REPORT OF THE CHIEF PLANNING OFFICER **DATE 4 JANUARY 2021**

APPLICATION NO:
P/2018 /0915

LOCATION:
CENTRAL BUILDINGS AND
ADJOINING LAND BROOK STREET
WREXHAM
LL13 7LH

DESCRIPTION:
RESIDENTIAL DEVELOPMENT
COMPRISING CONVERSION OF
FIRST AND SECOND FLOORS OF
CENTRAL BUILDINGS TO PROVIDE
10 NO. APARTMENTS WITH
RELATED ALTERATIONS AT
GROUND FLOOR LEVEL AND
ERECTION OF 28 NO. APARTMENTS
ON ADJACENT LAND WITH
ASSOCIATED PARKING

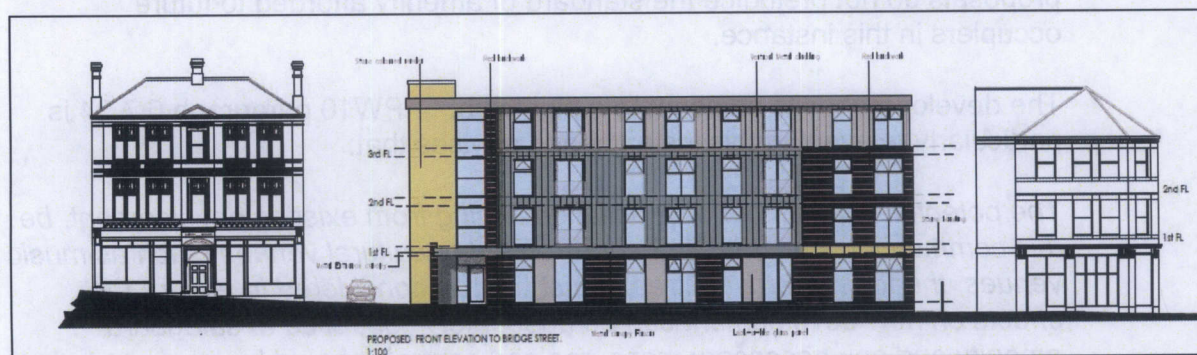
The new building is of a contemporary design – see plan below:

The proposals represent a contrast to the buildings either side of the site which are both of a more traditional appearance. Burton Buildings to the south-west is Grade II listed. There is nothing in the UDP policies or the Masterplan that would discourage contemporary architecture. Furthermore the buildings in the immediate locality display a wide range of architectural styles, reflecting the fact that this part of the town has developed incrementally over time. I consider the proposed building to be appropriate in terms of its scale and appearance, will represent a significant enhancement to the site and the immediate locality and to be broadly in accordance with guidance in the Masterplan. The proposals will also not detract from the setting of the adjacent listed building.

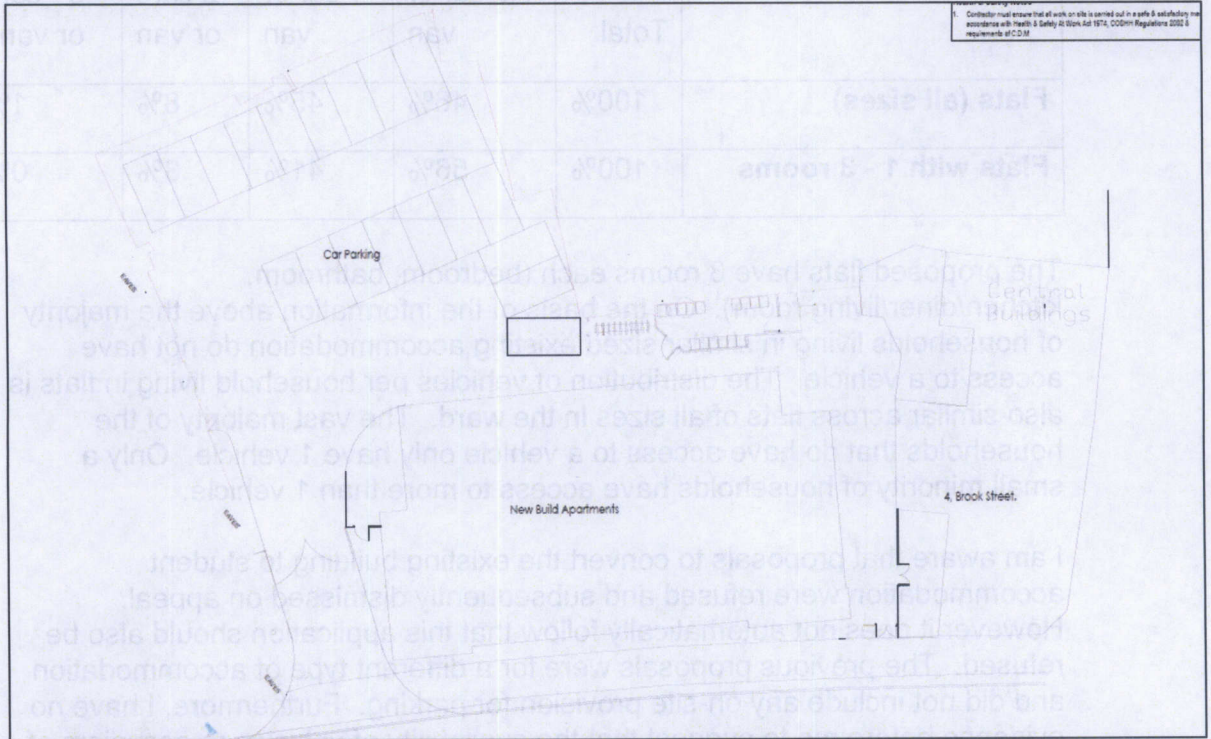
Access and Parking: The site will be provided with a new access onto Bridge Street. The proposed site layout plan is shown below:

The layout and design of the access meet with Highways requirements. Adequate visibility can also be provided. The applicants have also provided additional plans in response to a request from Highways which demonstrate that a refuse vehicle can enter and leave the site safely. The plans also confirm that such a vehicle can turn within the site. I am therefore satisfied that the proposals do not pose a danger to highway or pedestrian safety.
